ITEM 5. DEVELOPMENT APPLICATION: 188-194A AND 196-208 GEORGE STREET 4 DALLEY STREET AND 1 UNDERWOOD STREET SYDNEY**FILE NO:** D/2012/893**DEVELOPMENT APPLICATION NO:** D/2012/893**SUMMARY****Date of Submission:** 13 June 2012 (amended plans received 15 October 2012).**Applicant:** Mirvac Projects Pty Ltd**Architect:** FJMT**Developer:** Mirvac Projects Pty Ltd**Landowner:** Mirvac George Street Pty Ltd
Mircvac Funds Ltd**Proposal Summary:** The subject application seeks consent to demolish the buildings at 188-194A and 196-208 George Street and part of the building at 4 Dalley Street, the construction of a 37 storey commercial building and refurbishment of the remainder of the 4 Dalley Street building. The development will include:

Development Application No. D/2012/893 is recommended for deferred commencement consent.

Figure 10 – Proposed facade Option 1

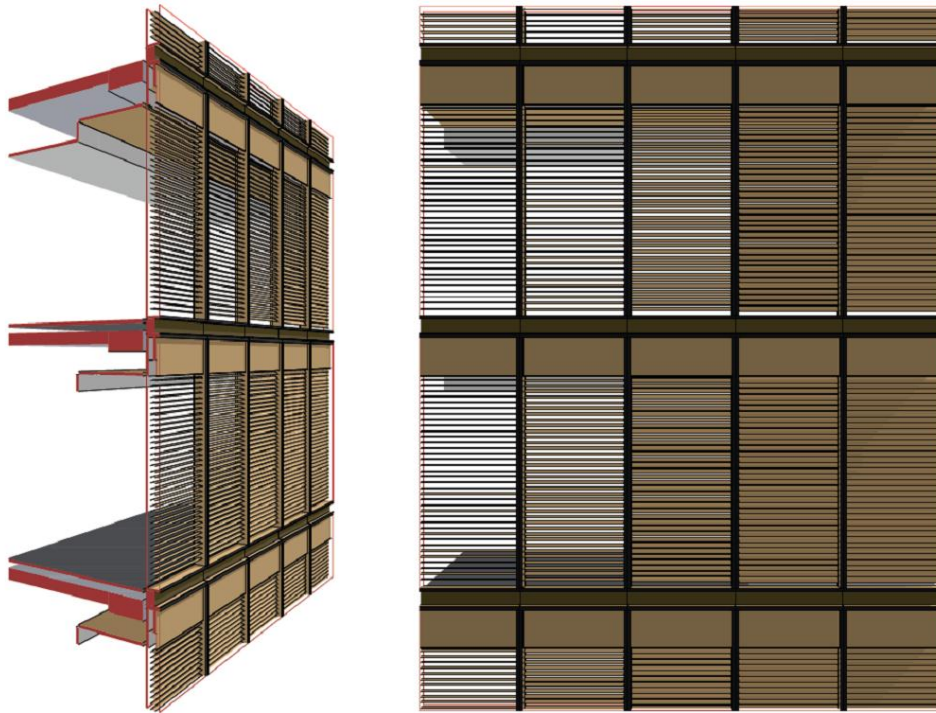
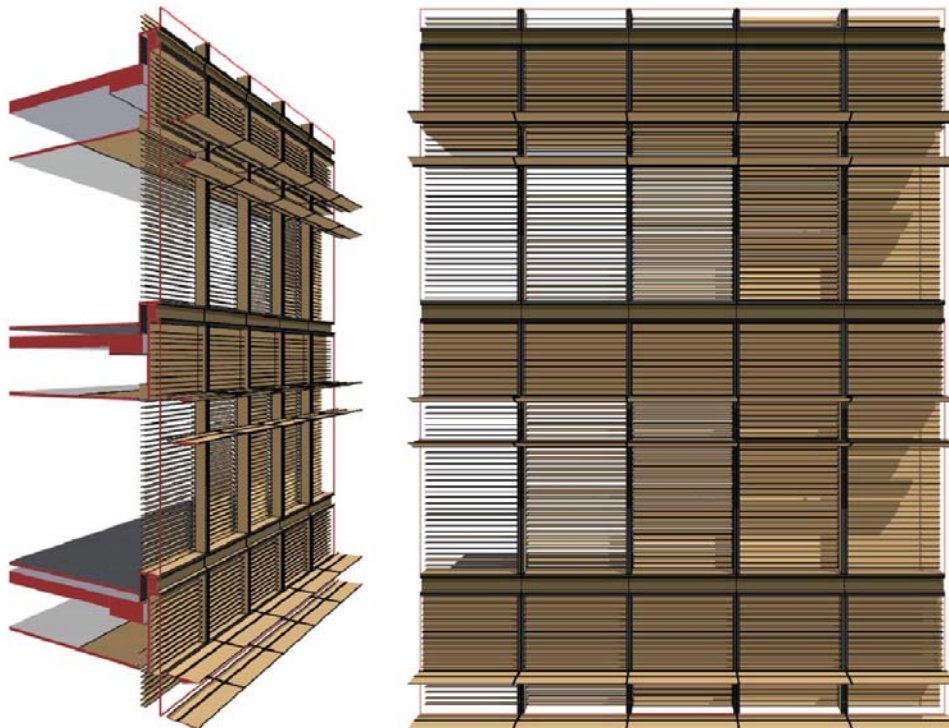
- (b) The flexibility to allow two facade options to the northern floor plate of the proposed tower (levels 4-36) and the southern floor plate (levels 4-10, 14-24 and 26-35). Option 1 is a triple glazed façade with integrated timber (or equivalent) blinds and an external single glazed skin of clear glass. Option 2 is a double glazed skin with internal timber blinds and external horizontal sunshades. These are shown in **Figures 10 and 11** below. Selected plans and photomontages are also provided further below showing the building from various vantage points illustrate both facade options.

Figure 25 – tower footprint comparison of APDG envelope (shown dotted) and proposal

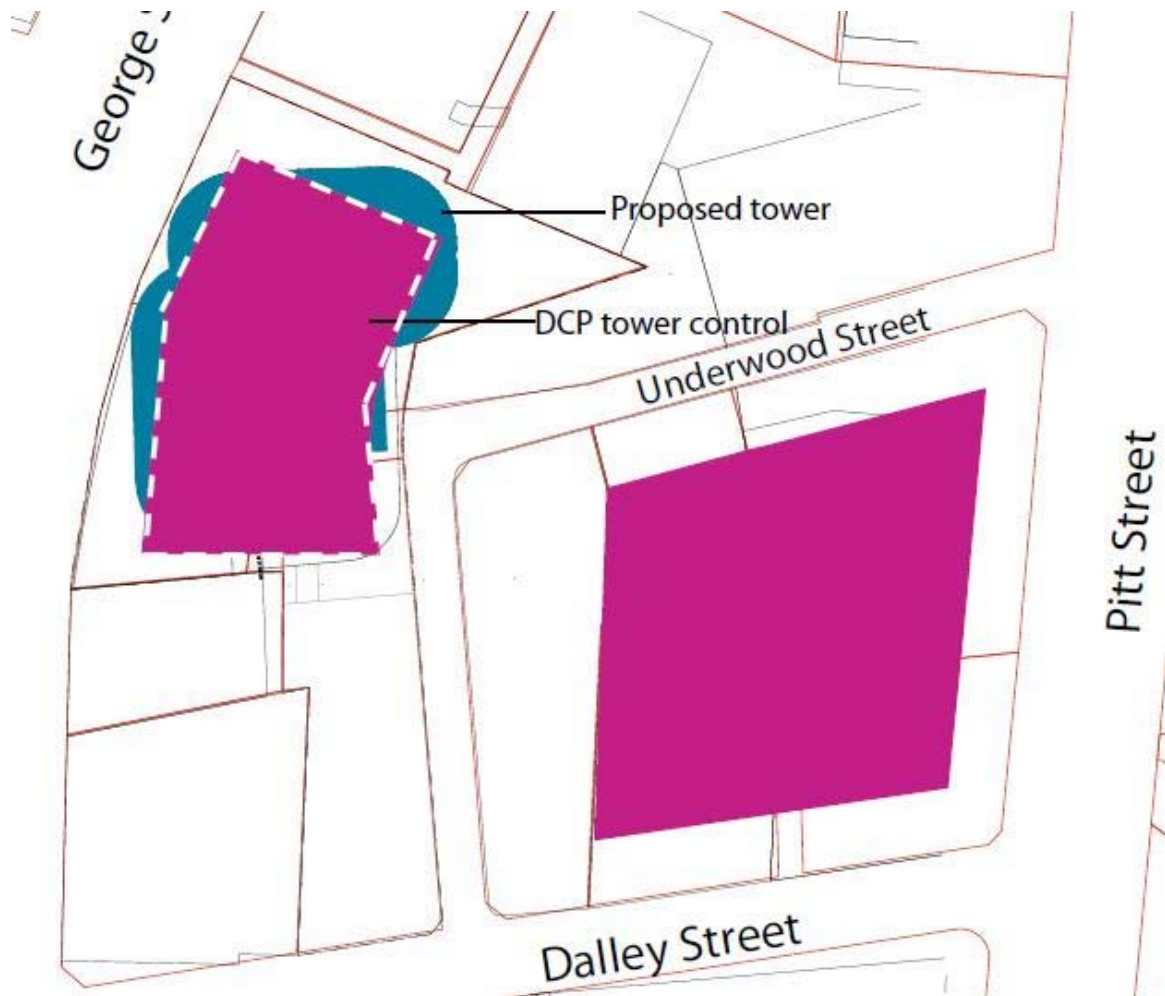
75. The amended proposal has adjusted the position of the tower in a general south-westerly direction. The new position increases the building separation to the north to 4,500mm (additional 550mm) and reduces the tower overhang of the future public road in the north east corner to a maximum of 1,800mm (800mm less). The 4,500mm setback comprises a combination of the existing Council owned Crane Place (approximately 2,400mm wide) and a setback from the northern boundary. The tower overhang is at a high level ranging at between 20-22m.
76. Notwithstanding this adjustment in the position of the tower, there are parts that do not comply with the APDG required tower setbacks. The following diagram provides a visual comparison of the proposal with the required setbacks.

77. The proposed tower setbacks, including the partial overhang over the future public road, has merit and is supported. In particular, the following matters are noted:

Figure 37 - proposed east (Underwood St) elevation

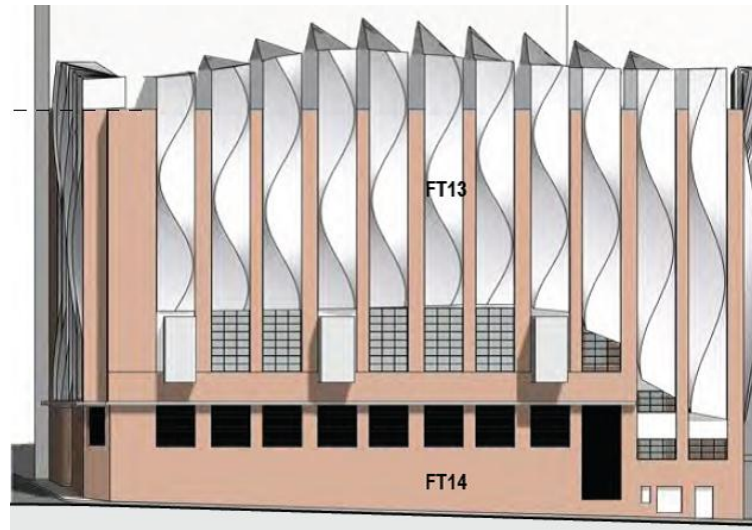
The external design treatment to 4 Dalley Street shown on drawing numbers DA1211, 1202, 1222 is not approved. An alternative design treatment for the 4 Dalley Street building that shall remain shall be submitted to the Director City Planning, Development and Transport for approval within five months of the date of the consent becoming operative.

116. The submitted facade design for the retained and refurbished building is conceptual in nature and comprises aluminium composite cladding, metal mesh and louvre cladding (FT13 in Figures below) with the balance being face brickwork (FT14). The images below are the submitted elevations:
